1984 Corvette: Service Bulletin: Broken Window Regulator Tapes

Bulletin No: 84-3

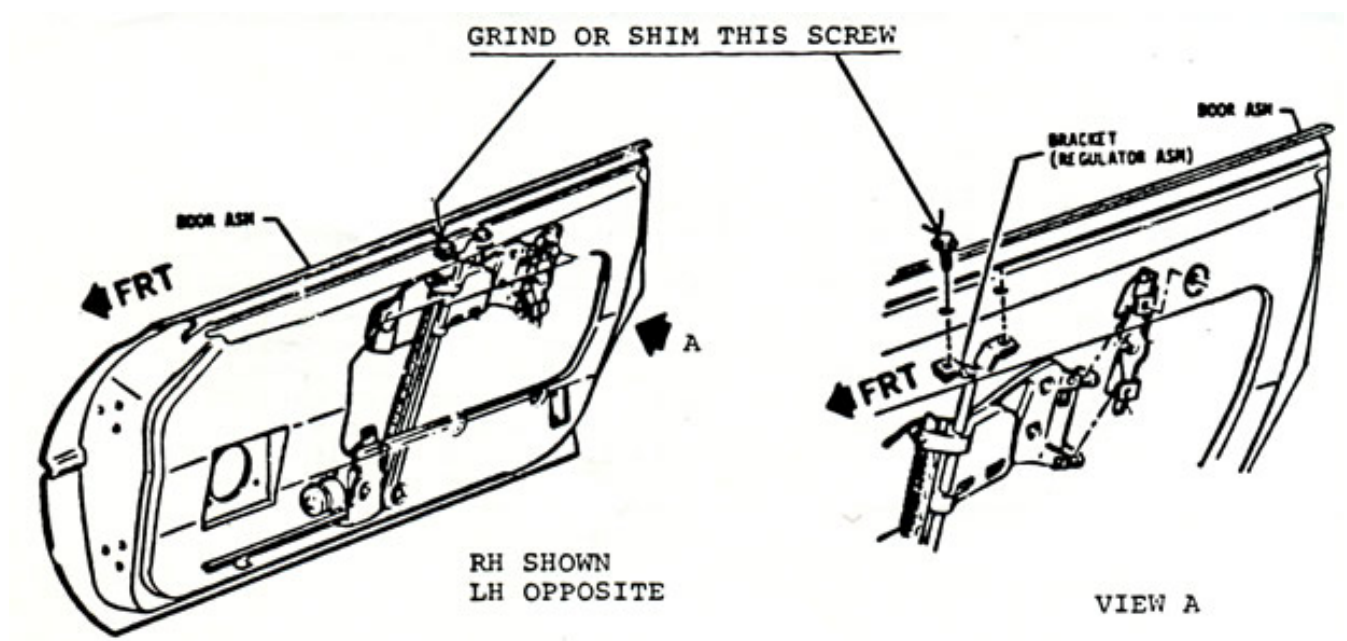
Whenever a vehicle requires service of door components, inspect for interference between the forward upper attaching screw and the upper end of the tape drive. If interference exists, one of the following options should be performed:

1. Add a washer (P/N 14038397), or equivalent, under the upper forward attaching screw (See Illustration).
2. Remove the forward attaching screw (P/N 11503800) and grind approximately 3mm from the threaded end.

This is to prevent contact between the bottom of the screw and the upper end of the tape drive. If this contact exists, excessive stress is created in the tape and could cause a failure.
